Memorandum to the City of Markham Committee of Adjustment

March 11, 2025

File: A/012/25
Address: La Tache Crescent, Markham
Applicant: Baldassarra Architects Inc. (Milica Zekanovic)
Hearing Date: Wednesday, March 19, 2025

SITE PLAN

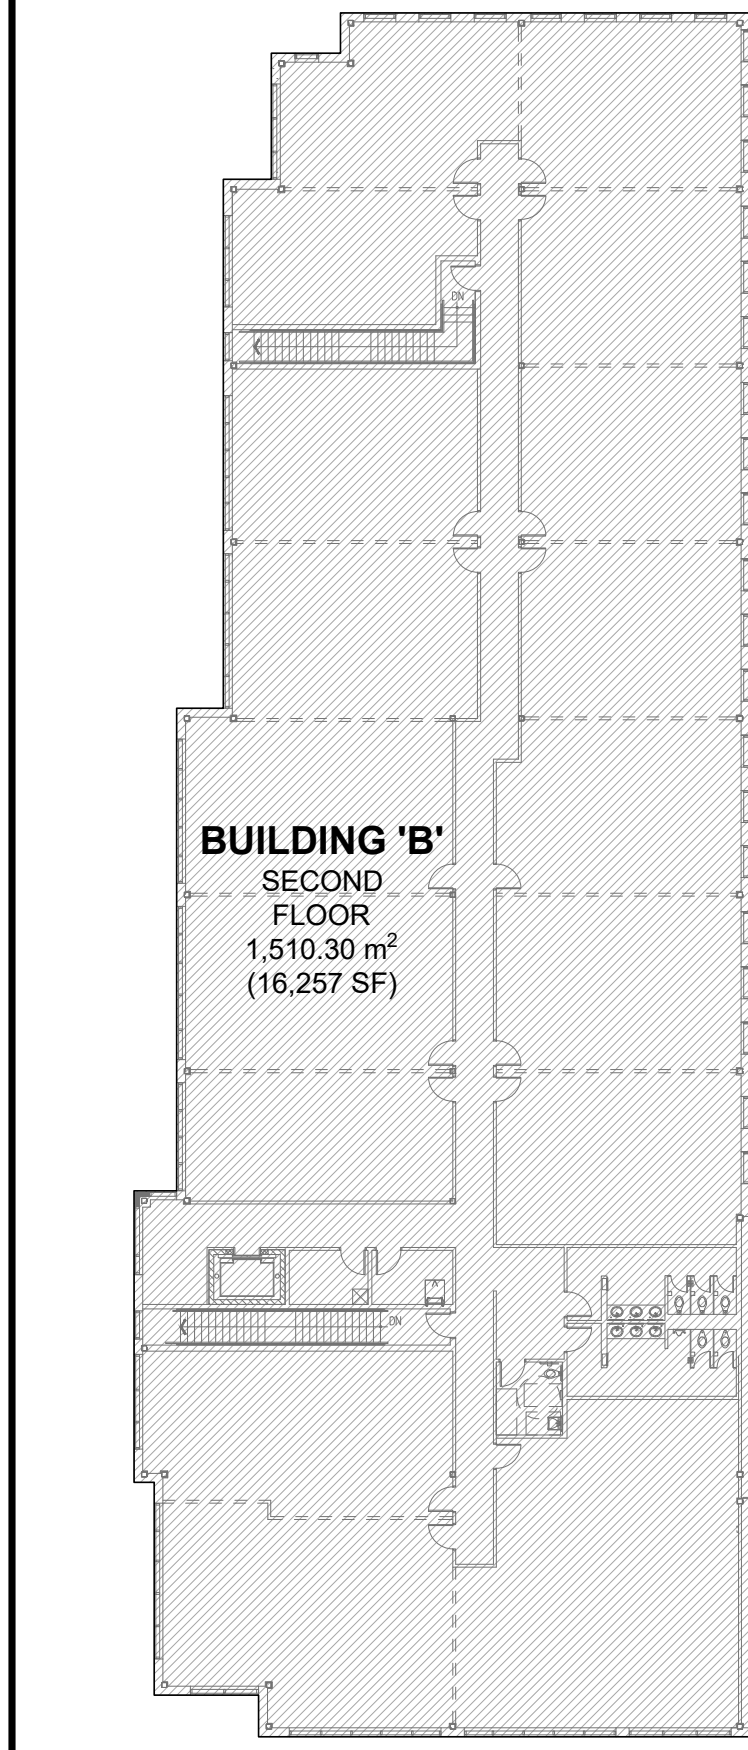
The Owner has requested a two-way driveway/site access width of 4.5 metres, whereas the By-law requires a minimum two-way driveway/site access width of 6.0 metres. The Owner is required to provide a shared access with the property to the south. Therefore, the site will ultimately provide for the required 6.0 m two-way driveway/site access, however, a portion will be located on the property to the south (See Site Plan, Appendix B).

Given the above, Staff have no concerns with the reduction to the two-way driveway/site access width. It should also be noted the Owner will be required to establish reciprocal easements for the purpose of access through the associated Site Plan Control application and agreement.
